State of Alaska  
Department of Fish and Game  
Sportfish Division

Nomination Form  
Anadromous Waters Catalog

Region Southeastern USGS Quad(s) SKAGWAY B-2 B-3  
 Anadromous Waters Catalog Number of Waterway 115-32-10250-2052 (2050)  
 Name of Waterway \_\_\_\_\_  USGS Name  Local Name  
 Addition  Deletion  Correction  Backup Information

**115-32-10250-2050 Correction**

Figure 1:115-32-10250-2050 Correction Map

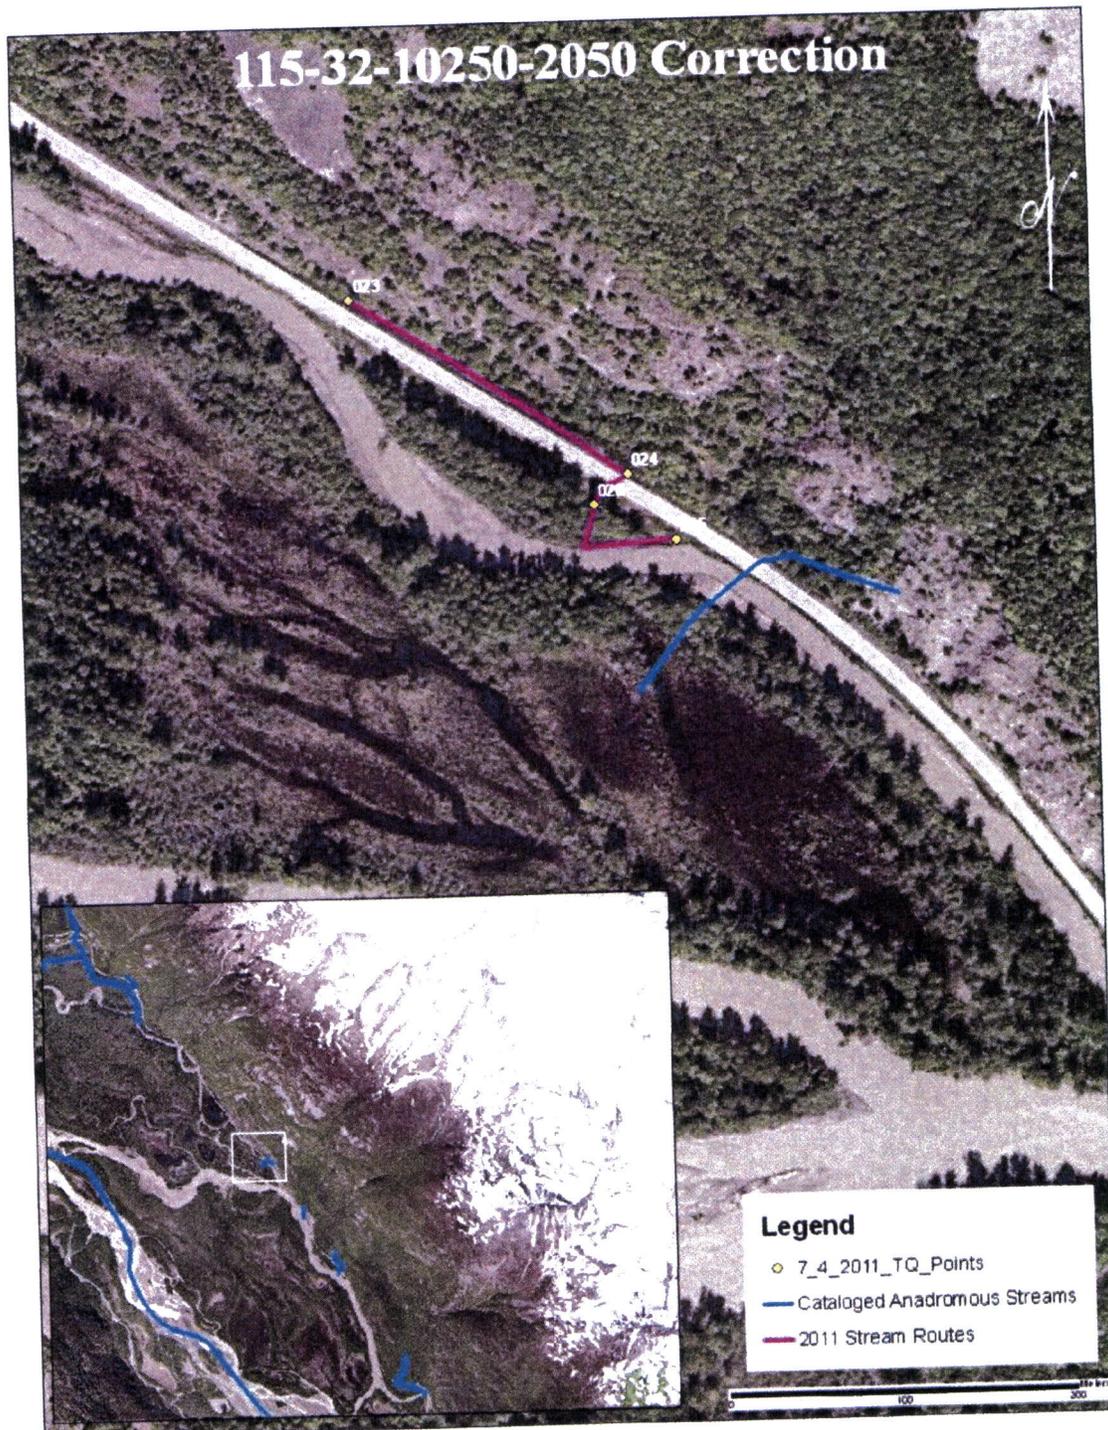
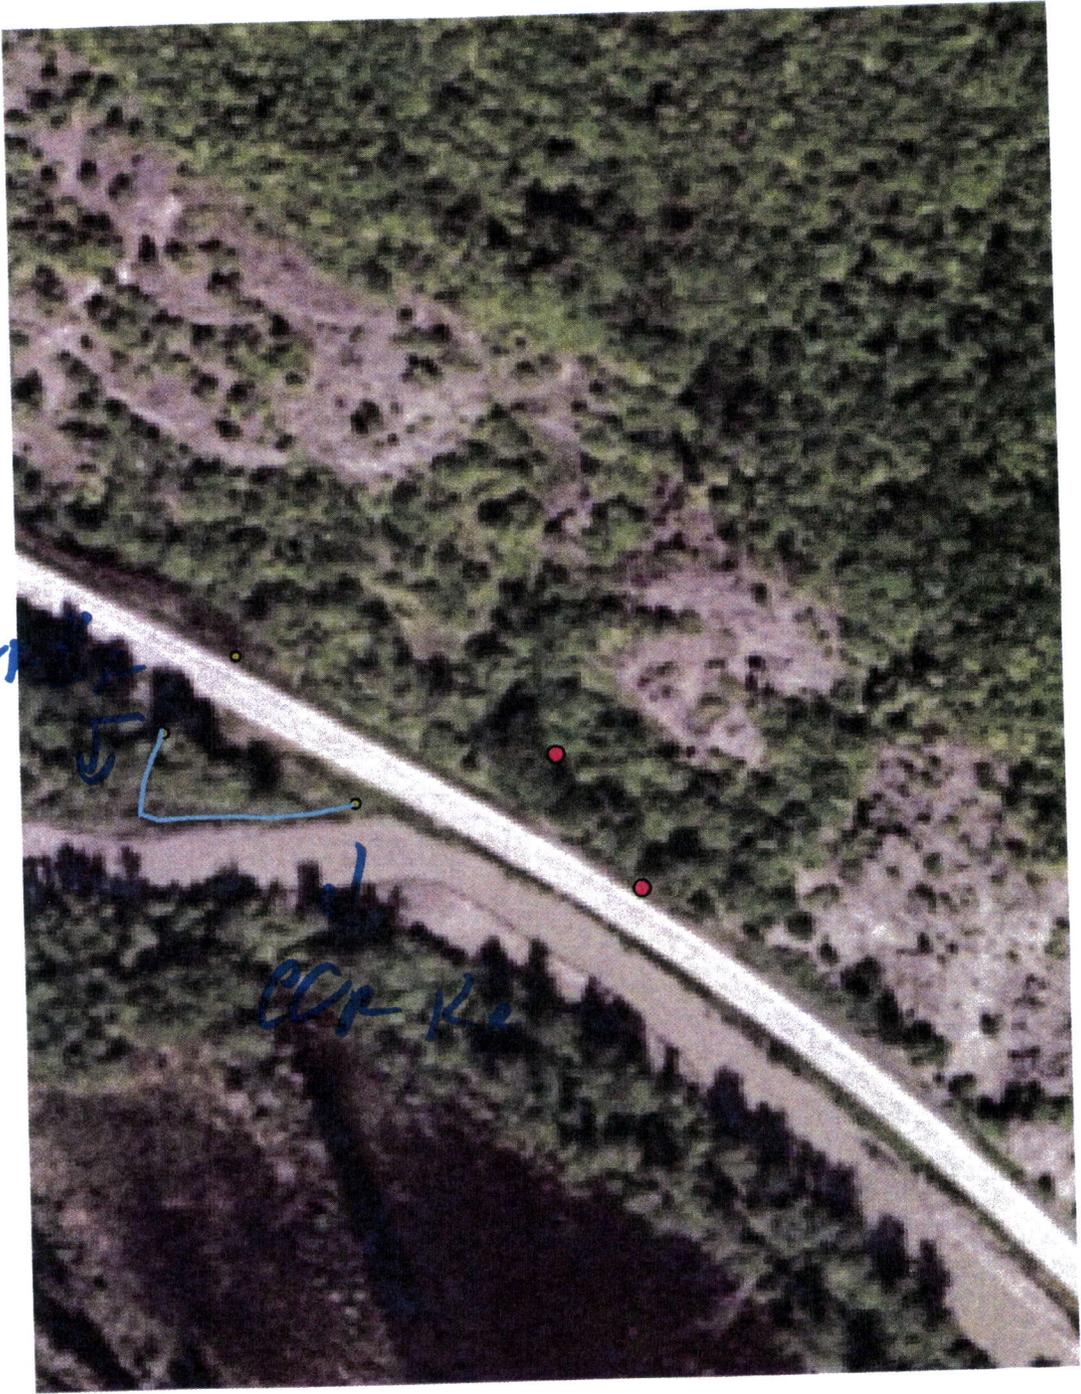
Reposition 115-32-10250-2050 <sup>BDL</sup>  
move upper, lower pts, retain Chinook salmon -  
REARING, add coho salmon. REARING

blue polyline line represents location for existing  
115-32-10250-2050, renumber as 115-32-10250-2052  
and remove Chinook salmon rearing

black polyline represents location of original AWC #  
115-32-10250-2050, highlighted light blue  
portion of amethyst polyline represents location for "new"  
115-32-10250-2050 w/Chinook salmon rearing  
add 115-32-10250-2050 w/Chinook salmon rearing,  
use noms\quinn\KateHainesStreams.shp.ed\KateHainesStreams.shp for hydro
